3FM PROJECT

RFI Response Report

Case Reference PA29N.320250 / ABP-320250-24

MH19016N
3FM Project
F01
1st October 2025

Location: Existing Accesses Along Alexandra Road (S26-HGN-NP-DR-HE-100-0004)

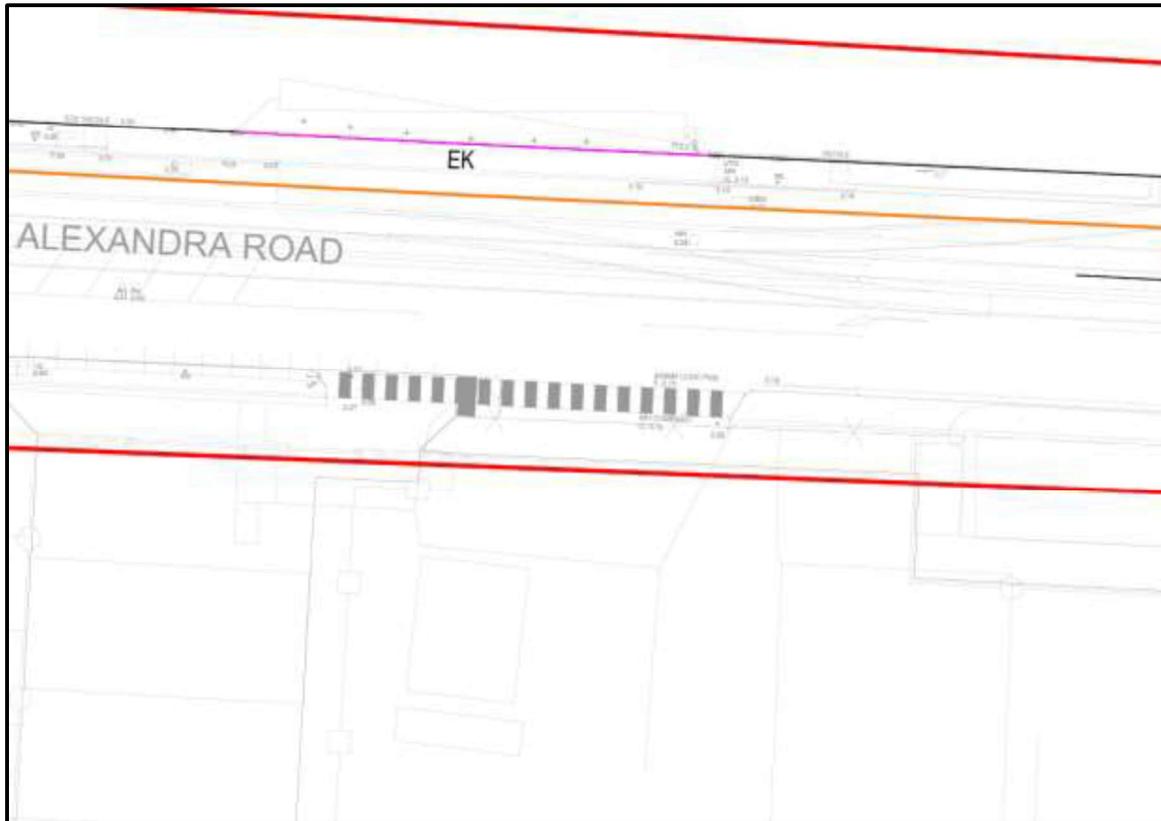
The audit team note that there are no proposals to include for upgrades of existing accesses along Alexandra Road. There is no tactile paving or dropped kerbs at existing accesses which could result in trip and falls among vulnerable users.

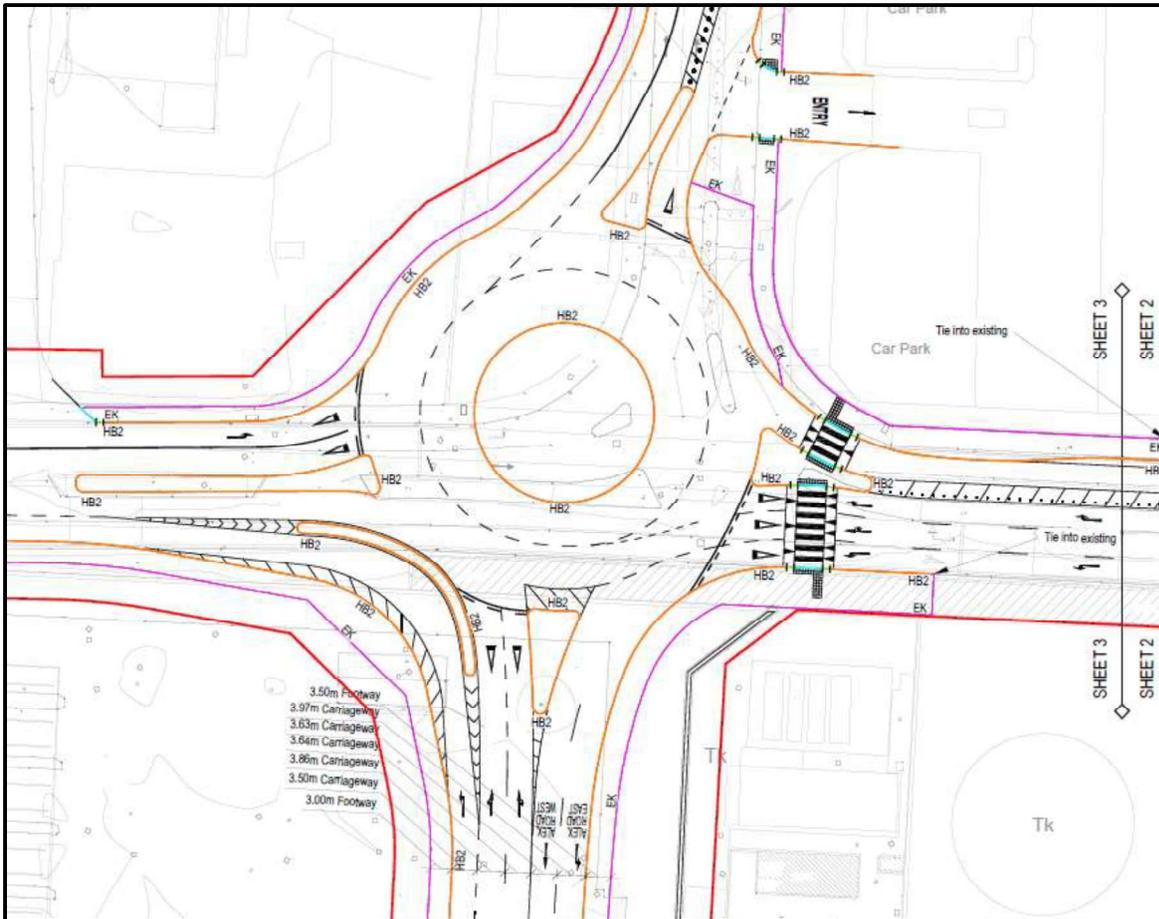
The audit team note that the existing access point is excessively wide with no pedestrian crossing facilities. The audit team note at the time of the visit that vehicles were parked at the location identified which is restricting the passage of vulnerable users. The parked vehicles couple with the lack of appropriate crossing facilities creates a significant hazard for vulnerable users.
